CERTIFICATE OF APPROPRIATENESS

Property: 1501 Ashland St, East 88' of Lot 18, Tract 18B, Block 146, Houston Heights Subdivision. The property includes a historic 800 square foot, one-story wood frame single-family residence situated on an approximately 2,900 square foot lot (≈ 88' x 33') corner lot.

Proposal: Alteration – Addition

SOUTH (FRONT) FACING W 15TH
PROPOSED

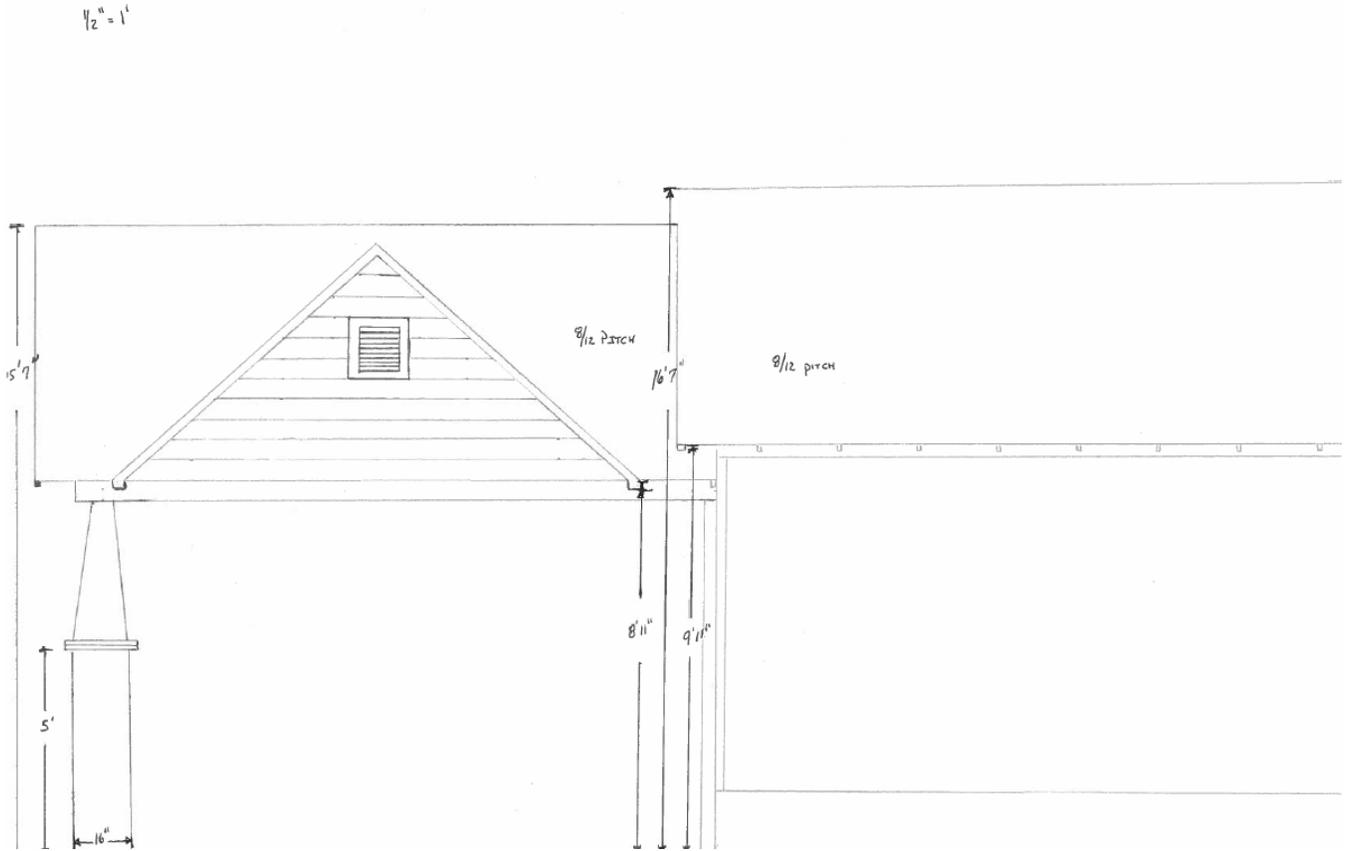
<i>The front-facing gable on the carport draws attention away from the historic residence. The gable extends 2' beyond the 16" eave overhang and is very prominent. Carports are accessory structures and should be subordinate to the existing residence. Accenting an accessory structure with a prominent gable visible from the street is not appropriate.</i>

<i>The front-facing cross gable on the carport is not compatible with the character of the property or the context area. Carports are accessory structures and should be subordinate to the existing residence. Accenting an accessory structure with a prominent gable visible from the street is not appropriate.</i>

Recommendation: Approval with conditions: Approval for attached carport with the condition that the front-facing gable be removed.

<i>Staff believes the project would meet Criterion 1 if the applicant were to eliminate the gable.</i> |

<i>Staff believes the project would meet Criterion 10 if the applicant were to eliminate the gable.</i> |
